Subject: Minutes for 50th Protection Sub-Committee Meeting.

50th Protection Sub-Committee Meeting (29th April, 2024)-MoM

Minutes of
50th Meeting of Protection Sub-Committee (PSC) of
Northern Regional Power Committee

Proposed Protection Scheme from UPPTCL 33KV OG fdr to NPCL network with Cable Differential Protection

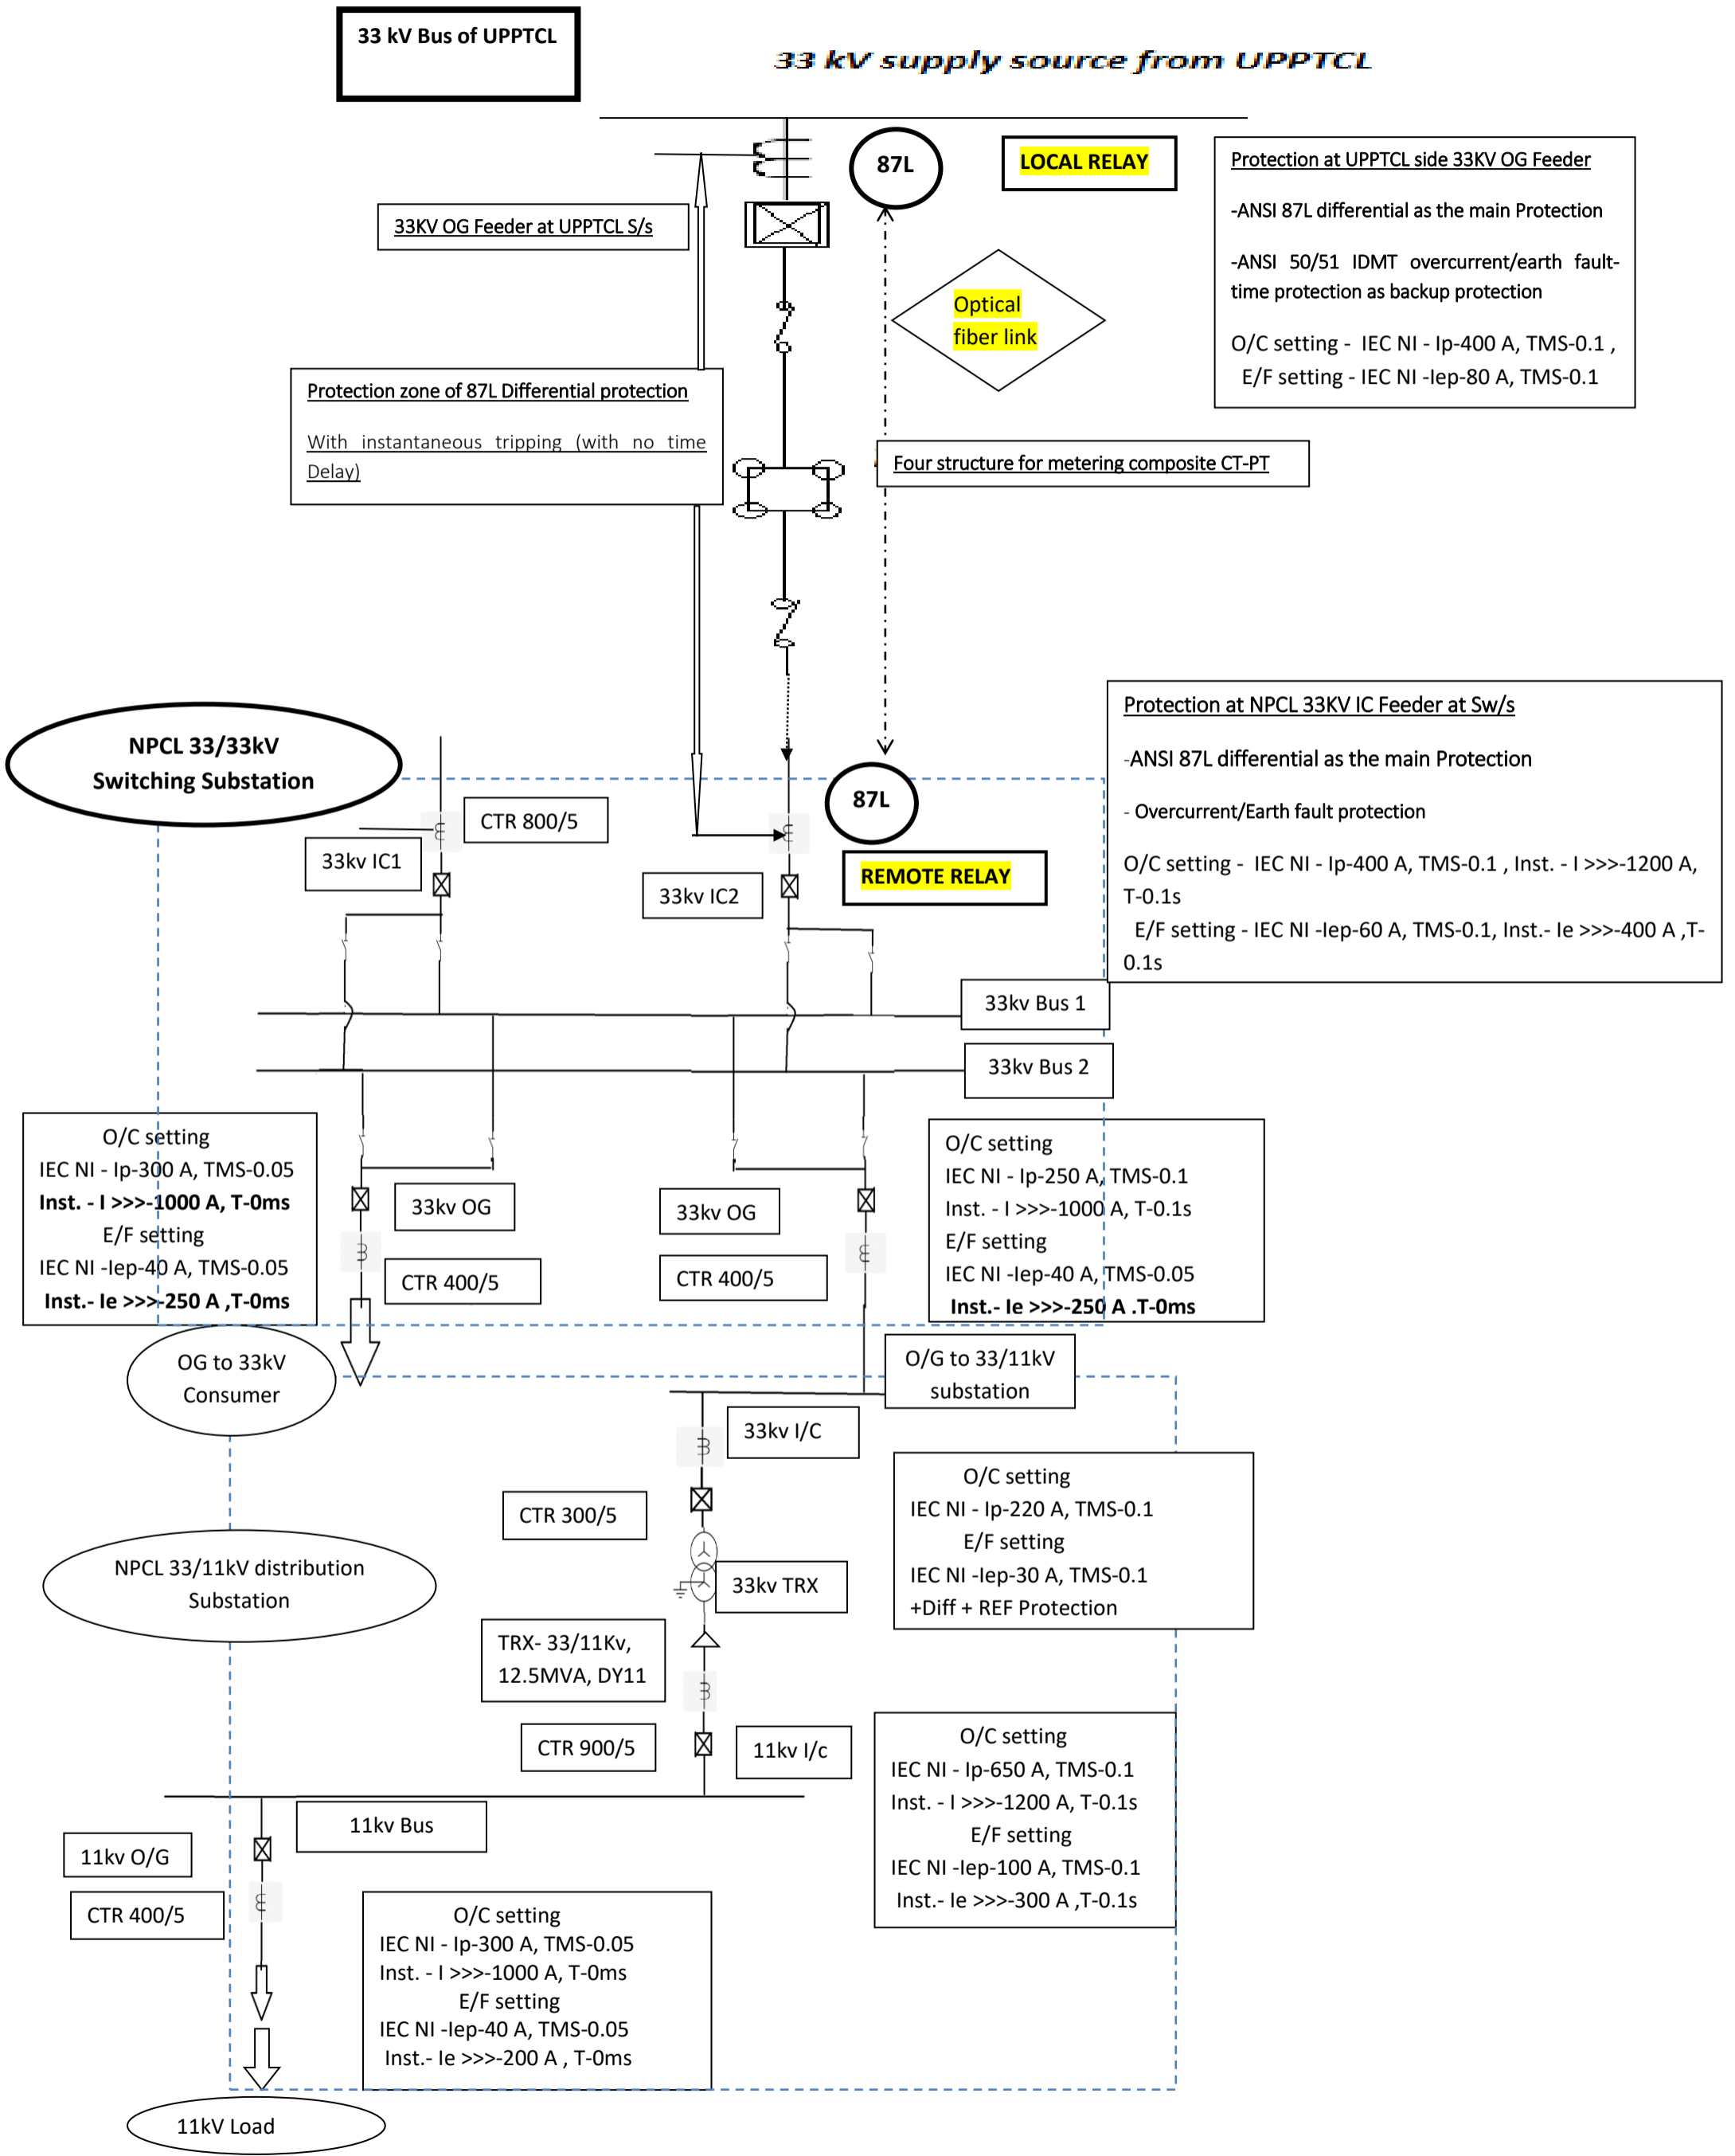
A.3.9 UPPTCL representative mentioned that before implementation of differential protection, techno economical analysis is to be done. He added that UPPTCL will discuss with NPCL to resolve the matter.
